**Endangered and Threatened Wildlife; Sea Turtle Conservation Requirements**

**ACTION:** Final rule.

**SUMMARY:** NMFS is amending the turtle excluder device (TED) regulations that require most shrimp trawlers to use Turtle Excluder Devices (TEDs) in the southeastern Atlantic and the Gulf of Mexico, to reduce the incidental capture of endangered and threatened sea turtles during shrimp trawling. Specifically, NMFS is allowing the use of a design of

**Figure 1.** Illustration of offshore hooped hard TED dimensions, showing optional water deflector fin.

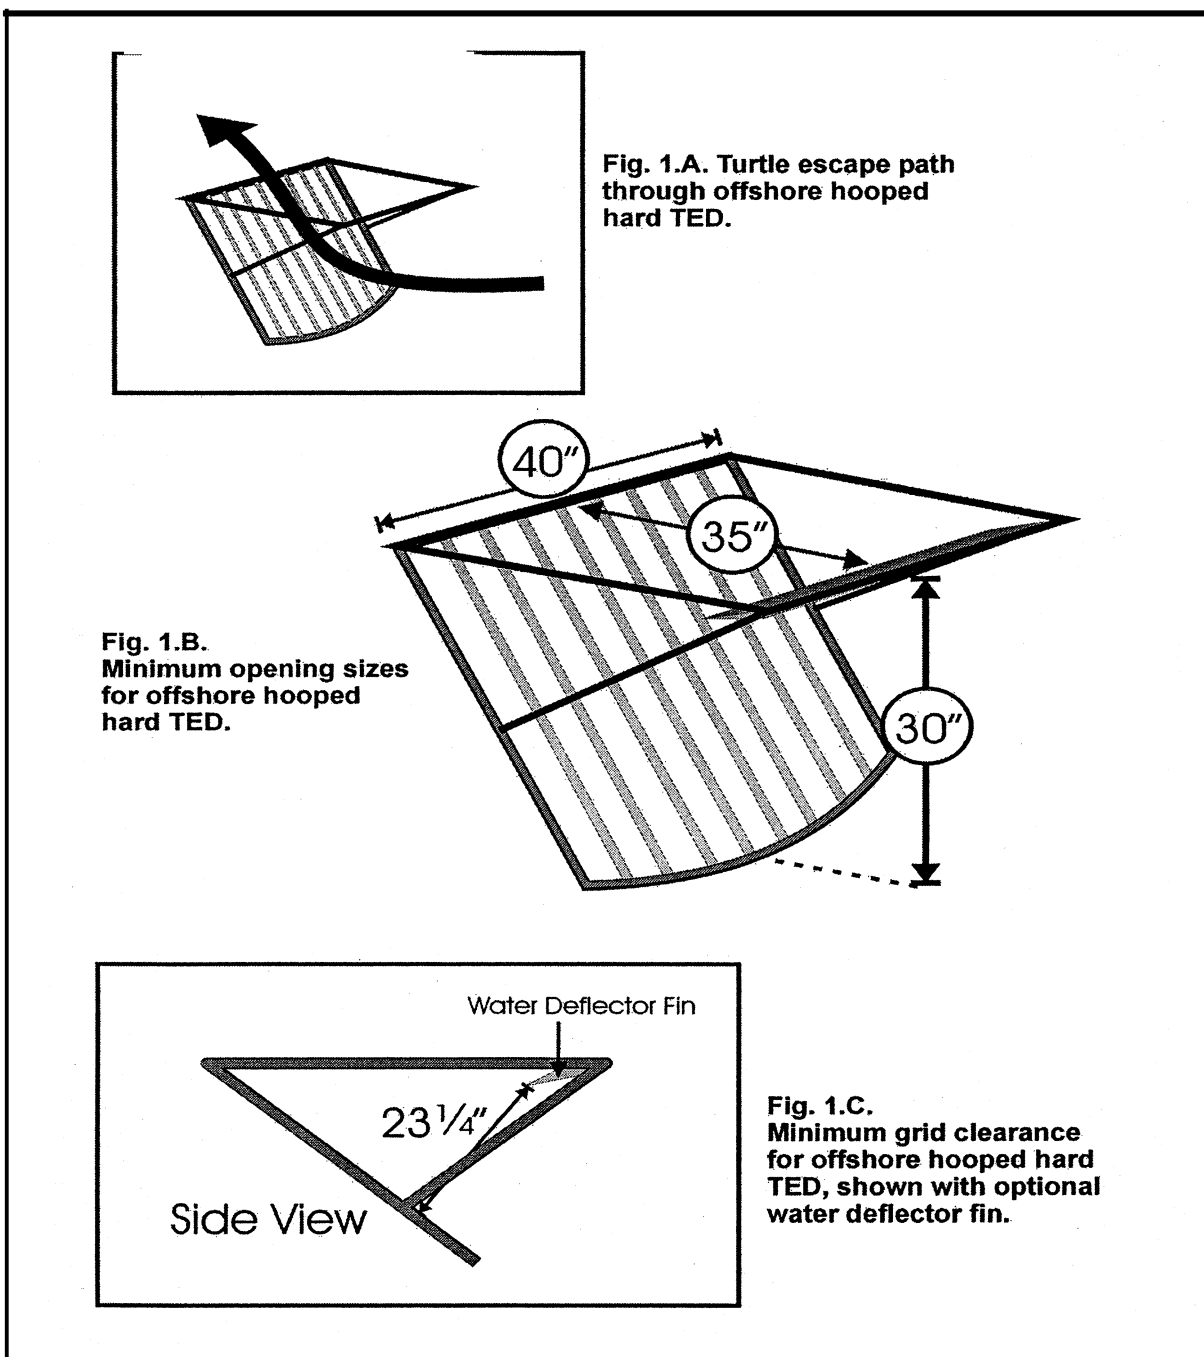
NMFS is issuing a rule allowing the use of an offshore hooped hard TED that

has to meet certain minimum construction standards, in addition to the construction standards specified for hard TEDs generally. The frame for this TED must be made of aluminum rod with a minimum outside diameter of 5/8 inch (1.59 cm) or aluminum tubing with a minimum outside diameter of 1 inch (2.54 cm) and a minimum wall thickness of 1/8 inch (0.32 cm). The escape opening must have a horizontal measurement of no less than 40 inches (102 cm) wide and a forward measurement of no less than 35 inches (89 cm). The front hoop on an offshore hooped hard TED must have an inside horizontal measurement of at least 40 inches (102 cm) and an inside vertical measurement of at least 30 inches (76 cm). The minimum clearance between the deflector bars and the forward edge of the escape opening must be at least 23 1/4 inches (59 cm). The measurement between support bars must be no less than 40 inches (102 cm) (see Figure 1 for illustrations of the offshore hooped hard TED and its dimensions)

(ii) *Offshore hooped hard TED.* An offshore hooped hard TED must be constructed of aluminum, with minimum dimensions as follows:

(A) Solid rod with a minimum outside diameter of 5/8 inch (1.59 cm); or

(B) Tubing with a minimum outside diameter of 1 inch (2.54 cm) and a minimum wall thickness of 1/8 inch (0.32 cm).

(B) \ The offshore hooped hard TED escape opening must have a horizontal measurement of no less than 40 inches (102 cm) wide and a forward measurement of no less than 35 inches (89 cm). A hinged door frame may be used to partially cover the escape opening as provided in paragraph (d)(7) of this section. Alternatively, a webbing flap may be used as provided in paragraph (d)(3)(ii) of this section. The resultant escape opening with a webbing flap must have a stretched mesh circumference of no less than 142 inches (361 cm).

(B) *Offshore hooped hard TED.* The front hoop on an offshore hooped hard TED must have an inside horizontal measurement of at least 40 inches (102 cm) and an inside vertical measurement of at least 30 inches (76 cm). The minimum clearance between the deflector bars and the forward edge of the escape opening must be at least 23 1/4 inches (59 cm).

**Figure 2.** Hooped hard TED with optional hinged door frame and water deflector fin.

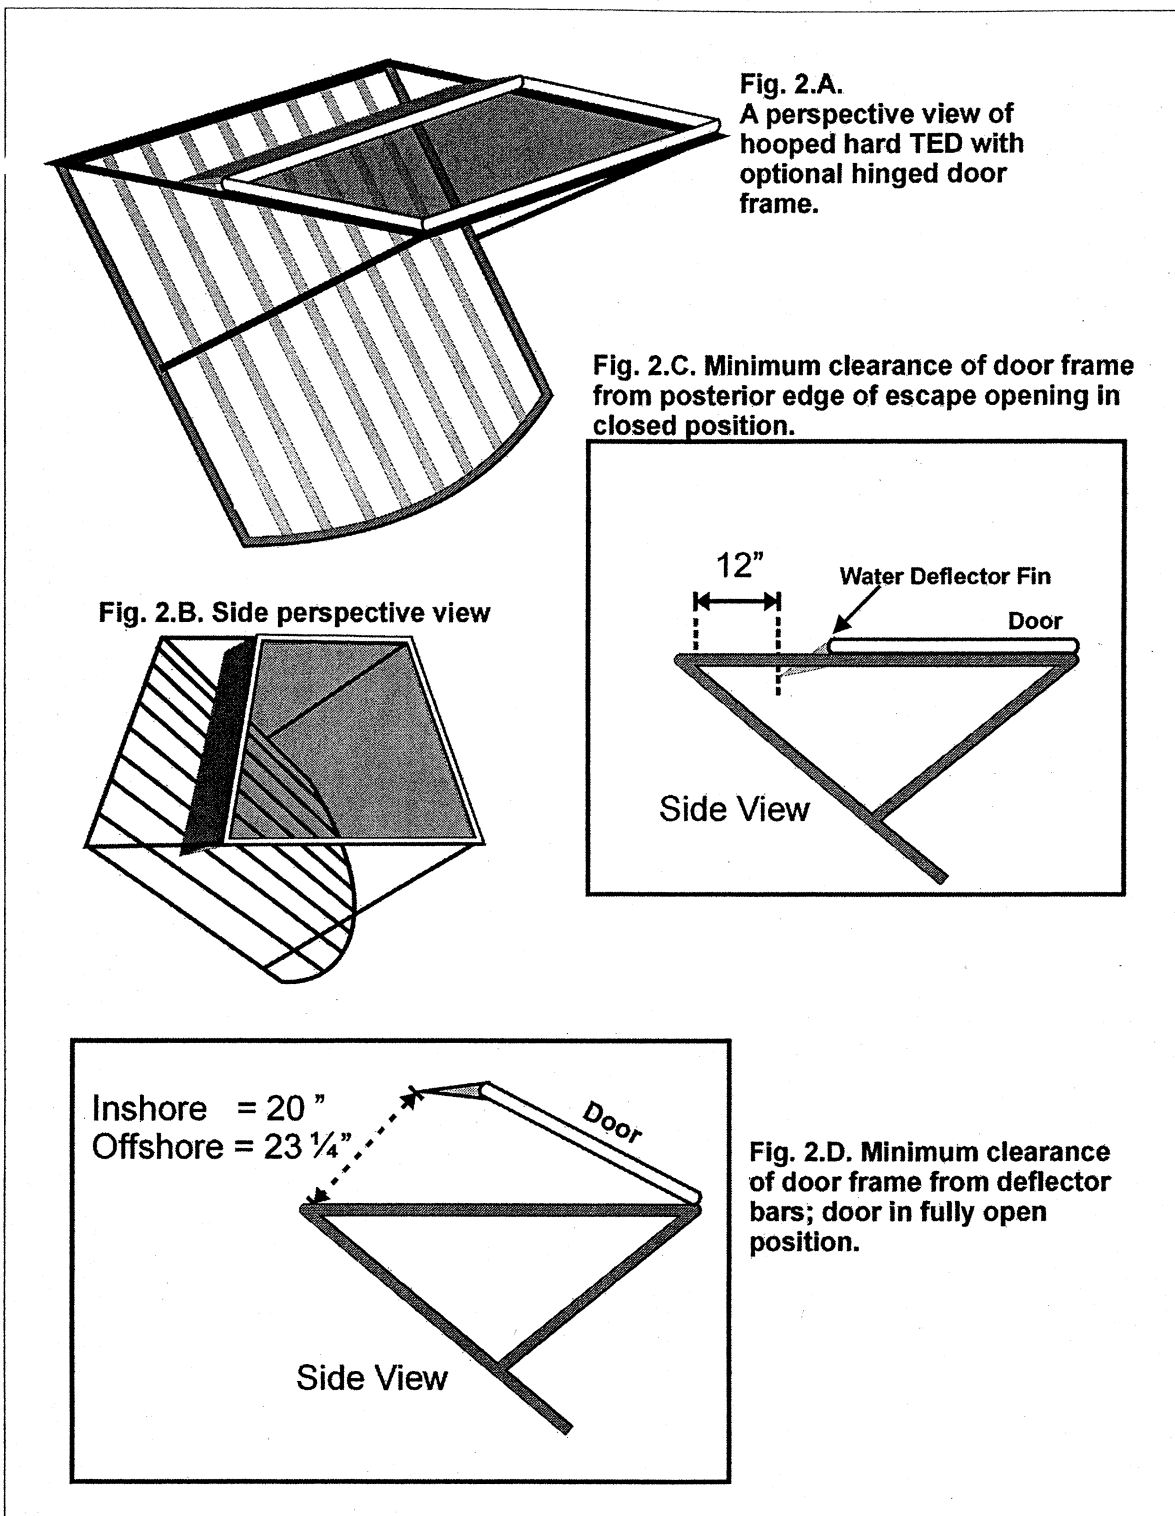
The third allowable modification for hooped hard TEDs is the use of a hinged

door frame to partially cover the escape opening. The door frame must be at least as wide as the escape opening, may be up to a maximum of 24 inches (61 cm) long, may be covered with taut mesh webbing (the size of the mesh cannot be greater than that used for the TED extension webbing), and must be connected to the forward edge of the escape opening by a hinge device that will allow the door to open upwards freely. The posterior edge of the door frame, in the closed position, must lie at least 12 inches (30 cm) forward of the posterior edge of the escape opening. If a water deflector fin is used with a hinged door it must be welded to the posterior edge of the door frame, projecting aft into the TED with an angle of 5–45 degrees from the normal, horizontal plane of the trawl. The fin must be constructed of a flat aluminum bar, up to 3/8 inch (0.95 cm) thick and up to four inches (10.2 cm) deep. The fin may be as wide as the width of the escape opening, minus one inch (2.5 cm). The deflector fin must be no less than 12 inches (30 cm) forward of the posterior edge of the escape opening, when the door is in the closed position. Two stopper ropes or a hinge limiter

may be used to limit the maximum opening height of the hinged door frame, as long as the minimum clearance between any part of the deflector bars and any part of the door, including a water deflector fin if installed, in its fully open position is at least 23 1/4 inches (59 cm) for an offshore hooped hard TED or at least 20 inches (51 cm) for an inshore hooped hard TED. The purpose of the stopper ropes or hinge limiters is to prevent the door frame from opening excessively during net deployment and haulback, possibly resulting in loss of catch or damage to the door. Any stopper ropes or hinge limiters must not restrict the free operation of the door, up to its maximum opening (i.e. the door must be able to easily swing to the required opening height before the stops or limiters affect its movement). The hinged door cannot be used in combination with a webbing flap or with a water deflector fin attached to the forward edge of the escape opening (See Figure 2 for illustration of the optional hinged door frame, shown with water deflector fin).

(7) *Hinged door frame for hooped hard TEDs.* A hinged door frame may be attached to the forward edge of the escape opening on a hooped hard TED. The door frame must be constructed of materials specified at paragraphs (a)(1)(i) or (a)(1)(ii) of this section for inshore and offshore hooped hard TEDs, respectively. The door frame may be covered with a single panel of mesh webbing that is taut and securely attached with twine to the perimeter of the door frame, with a mesh size not greater than that used for the TED extension webbing. The door frame must be at least as wide as the TED escape opening. The door frame may be a maximum of 24 inches (61 cm) long. The door frame must be connected to the forward edge of the escape opening by a hinge device that allows the door to open outwards freely. The posterior edge of the door frame, in the closed position, must lie at least 12 inches (30 cm) forward of the posterior edge of the escape opening. A water deflector fin may be welded to the posterior edge of the hinged door frame. The fin must be constructed of a flat aluminum bar, up to 3/8 inch (0.95 cm) thick and up to four inches (10.2 cm) deep. The fin may be as wide as the width of the escape opening, minus one inch (2.5 cm). The fin must project aft into the TED with an angle between 5° and 45° from the normal, horizontal plane of the trawl, when the door is in the closed position. The clearance between the posterior edge of the escape opening and the posterior edge of the door frame or the posterior edge of the water deflector fin, if installed, must be no less than 12 inches (30 cm), when the door is in the closed position. Two stopper ropes or a hinge limiter may be used to limit the maximum opening height of the hinged door frame, as long as they do not obstruct the escape opening in any way or restrict the free movement of the door to its fully open position. When the door is in its fully open position, the minimum clearance between any part of the deflector bars and any part of the door, including a water deflector fin if installed, must be at least 20 inches (51 cm) for an inshore hooped hard TED and at least 23 1/4 inches (59 cm) for an offshore hooped hard TED. The hinged

door frame may not be used in combination with a webbing flap specified at paragraph (d)(3) of this section or with a water deflection fin specified at paragraph (d)(6) of this section.
